PCN#20180329000
Qualify TI Mexico as an additional Assembly & Test site
for select PDIP devices
Change Notification / Sample Request

PCN Number:	20180329000		PCN Date:	April 16, 2018													
Title:	Qualify TI Mexico as an additional Assembly & Test site for select PDIP devices																
Customer Contact:	PCN Manager		Dept:	Quality Services													
Proposed 1st Ship Date:	July 16, 2018		Estimated Sample Availability:	Provided upon Request													
Change Type:																	
☒	Assembly Site	☐	Design	☐	Wafer Bump Site												
☐	Assembly Process	☐	Data Sheet	☐	Wafer Bump Material												
☐	Assembly Materials	☐	Part number change	☐	Wafer Bump Process												
☐	Mechanical Specification	☒	Test Site	☐	Wafer Fab Site												
☒	Packing/Shipping/Labeling	☐	Test Process	☐	Wafer Fab Materials												
		☐		☐	Wafer Fab Process												
PCN Details																	
Description of Change:																	
Texas Instruments is pleased to announce the qualification of TI Mexico as an additional Assembly & Test site for the list of devices shown below. Material differences between sites are as follows.

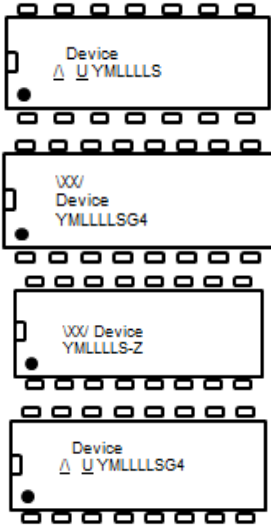
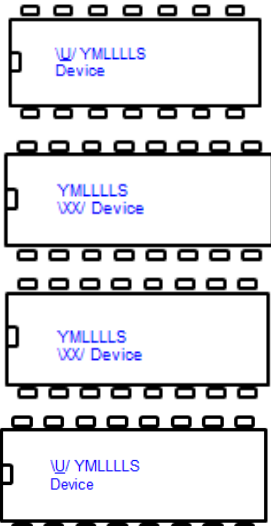
<table border="1"> <thead> <tr> <th>Assembly Site</th> <th>Assembly Site Origin</th> <th>Assembly Country Code</th> <th>Assembly City</th> </tr> </thead> <tbody> <tr> <td>Carsem</td> <td>CRS</td> <td>MYS</td> <td>Jelapang</td> </tr> <tr> <td>TI Mexico</td> <td>MEX</td> <td>MEX</td> <td>Aguascalientes</td> </tr> </tbody> </table>						Assembly Site	Assembly Site Origin	Assembly Country Code	Assembly City	Carsem	CRS	MYS	Jelapang	TI Mexico	MEX	MEX	Aguascalientes
Assembly Site	Assembly Site Origin	Assembly Country Code	Assembly City														
Carsem	CRS	MYS	Jelapang														
TI Mexico	MEX	MEX	Aguascalientes														
Material Differences:																	
<table border="1"> <thead> <tr> <th></th> <th>Carsem</th> <th>TI Mexico</th> </tr> </thead> <tbody> <tr> <td>Mount compound</td> <td>434165</td> <td>4147858</td> </tr> <tr> <td>Mold compound</td> <td>435006</td> <td>4211880</td> </tr> <tr> <td>Lead finish</td> <td>NiPdAu</td> <td>NiPdAu</td> </tr> </tbody> </table>							Carsem	TI Mexico	Mount compound	434165	4147858	Mold compound	435006	4211880	Lead finish	NiPdAu	NiPdAu

Carsem	TI Mexico															
Mount compound	434165	4147858															
Mold compound	435006	4211880															
Lead finish	NiPdAu	NiPdAu															
Marking Differences:																	
<table border="1"> <thead> <tr> <th></th> <th>Carsem</th> <th>TI Mexico</th> </tr> </thead> <tbody> <tr> <td>Group 1 Device</td> <td> </td> <td> </td> </tr> <tr> <td>Group 2 Device</td> <td> </td> <td> </td> </tr> </tbody> </table>							Carsem	TI Mexico	Group 1 Device			Group 2 Device					
	Carsem	TI Mexico															
Group 1 Device																	
Group 2 Device
